277 Spring Street	Owner: Alice Arless		Phone: 775	-2738	Permit No: 9 81268
Owner Address:	Lessee/Buyer's Name:	Phone:	Business	Name:	PERMIT ISSUED
Contractor Name: Pager: 264-2351	Address: 161 Fort Roed, So Portlan		767-06	76	Pernit Issued: / NOV 6 1998
Past Use:	Proposed Use:	COST OF WORK	.:	PERMIT FEE: \$50.00	
Hulti-femily	Same	FIRE DEPT. A		INSPECTION: Use Group: Type: .	CITY OF PORTLAND
		Signature:	my	Signature: + +	Zene:/ CBL:056-C-017
roposed Project Description:				S DISTRICT (P.A.D.)	Zoning Approve
Replace existing front steps & b. deers at entrance.	ick deck. Install double	A	pproved pproved wenied	vith Conditions:	Special Zone or Reviews:  Shoreland Wetland Flood Zone
		Signature:		Date:	☐ Subdivision
Permit Taken By:	Date Applied For:	11-2-96			☐ Site Ptan maj ☐minor ☐mm
<ol> <li>This permit application does not preclude the</li> <li>Building permits do not include plumbing,</li> <li>Building permits are void if work is not startion may invalidate a building permit and</li> </ol>	septic or electrical work.  rted within six (6) months of the date of iss	suance. False informa-			☐ Miscellaneous ☐ Conditional Use ☐ Interpretation ☐ Approved ☐ Denied

DATE: 5 Nou. 198 ADDR

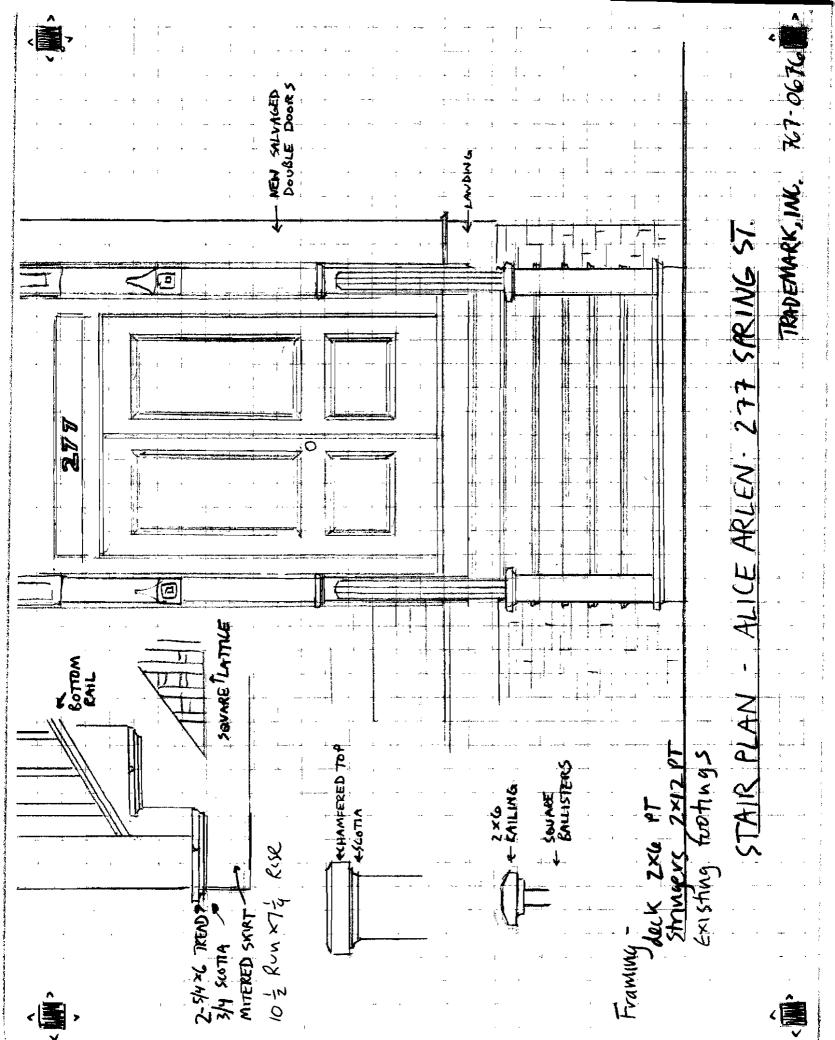
- 1. That the leading edge of the treads be rounded or bullnosed.
- 2. That the stairs and railing be painted within 6 months of installation; this will allow pressure-treated wood to dry.
- 3. That the final double-door selection be reviewed and approved by staff prior to installation.
- 4. That the ballusters be 2" square and spaced no more than 3 1/4" apart.
- That the contractor clarify the dimensions of the posts, and whether the posts will be cased.
   Posts should feature base or plinth, capped by base molding, as shown in section drawings provided by staff.
